Project No. 0151579

Subject: Response to Information Request Call - Air Liquide, LP Bayou Cogeneration Plant

**Attachment 1**  
**Air Liquide Bayou Cogeneration Plant**  
**GHG BACT Analysis**  
**Conceptual Cost Estimate for Carbon Capture and Sequestration**

## EXPECTED GAS TURBINE PLANT NON-RECOVERABLE PERFORMANCE LOSS DURING EXTENDED PERIOD OPERATION

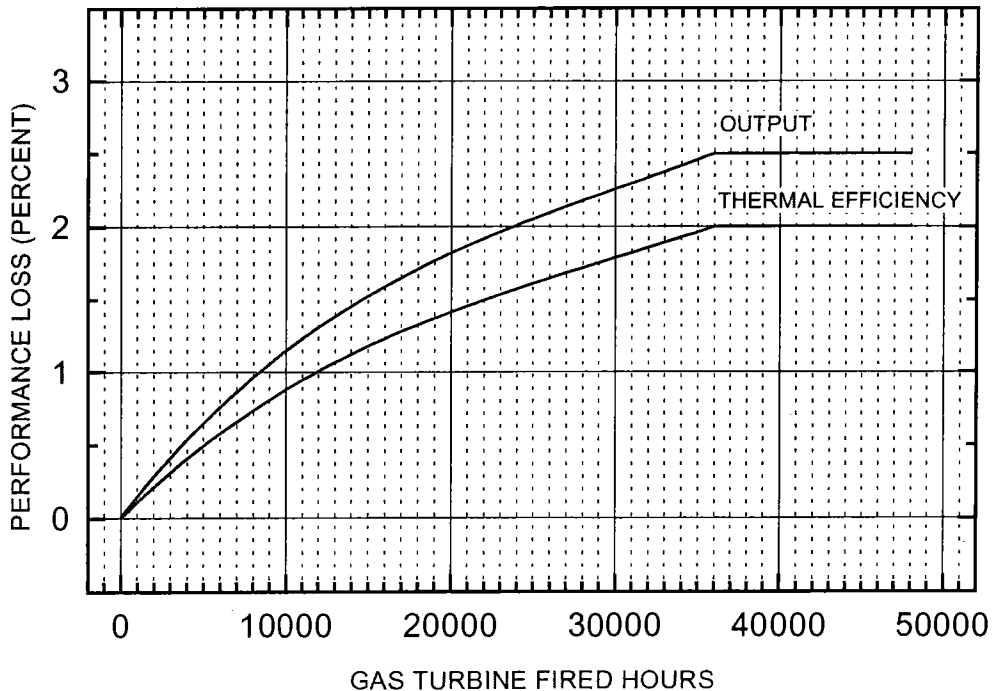
***RFI #4 - Please provide justification for the 3% degradation factor claimed on the BACT efficiency provided.***

Air Liquide is requesting a 3% adjustment to new and clean thermal efficiency to represent performance degradation over time. Attachments 2 and 3 show typical performance curves for GE turbines in regards to efficiency losses over time. Pages 45-47 in Attachment 4 show a performance curve for a generic turbine, as well as discussion of what causes that degradation loss. Based on the performance data provided, it is Air Liquide's opinion that a 3% adjustment is fully justified and would allow Air Liquide to operate the turbine according to the maintenance cycle recommended by the manufacturer.
